**Solitary Islands Village
Site Compatibility Certificate at Lot 1 DP1128964, Mullaway Drive, Mullaway**

Reference is made to our application for a Site Compatibility Certificate (SCC) for a proposed Senior Housing development on the above property and the Department's request for additional information.

Figure 2-1 Bushfire prone land

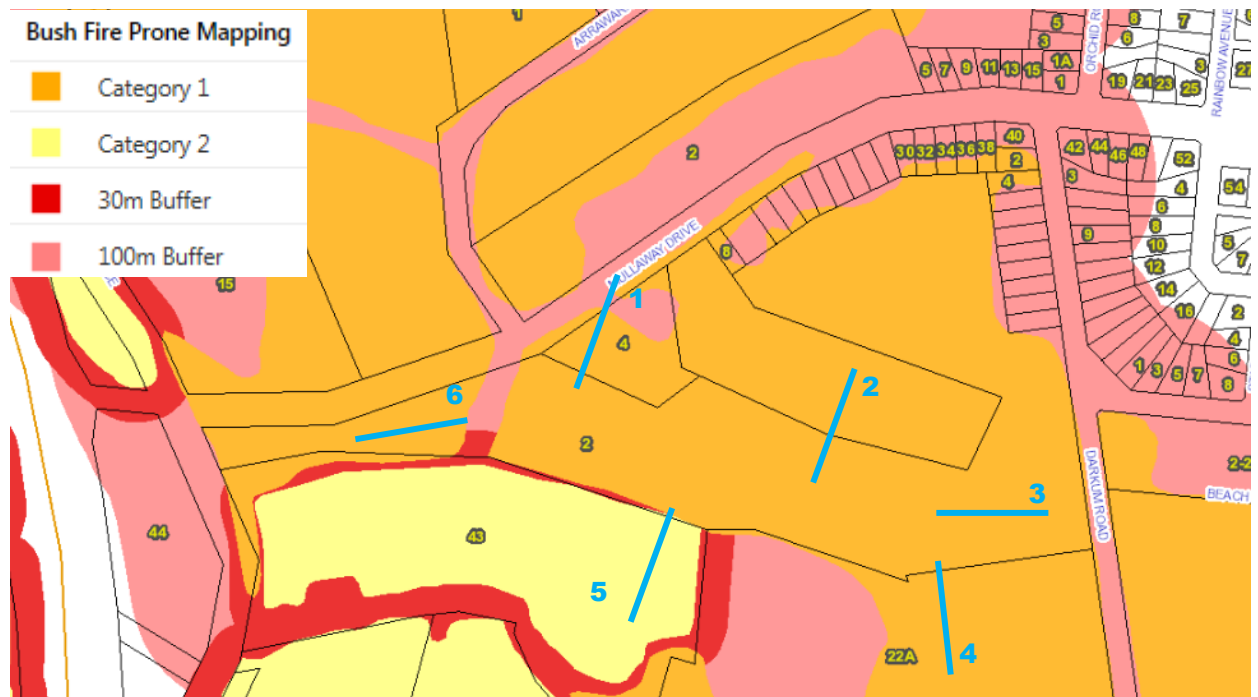
The site is identified as Bushfire Prone Land, as shown below. According to *Planning for Bushfire Protection* (PBP, 2006), the proposal is a “Special Fire Protection Purpose”. To provide an indication of the impact bushfire would have on the proposal a desktop assessment and site visit was undertaken.

PBP (2006) requires all aged care facilities to meet a maximum of 10 kW/m² at the entry and exits to the buildings. The current concept plan provides entry and exits points away from the hazards and the separation distances generally meet the APZ requirements in Table 1, however the site would need to be partially cleared of vegetation in accordance with PBP (2006). It is therefore considered that the concept design could meet the PBP (2006) requirements.

The current concept plan also provides a through road to allow emergency access and egress, in case of a bushfire. This would need to be design and constructed in accordance with PBP (2006) requirements, and include fire hydrants.

A meeting was held with NSW Rural Fire Service's (RFS) Alan Baldwin in Coffs Harbour to discuss the above assessment. The RFS clarified what their expectations are in regards to aged care developments and the level of assessment required and did not offer any objections to the proposal.
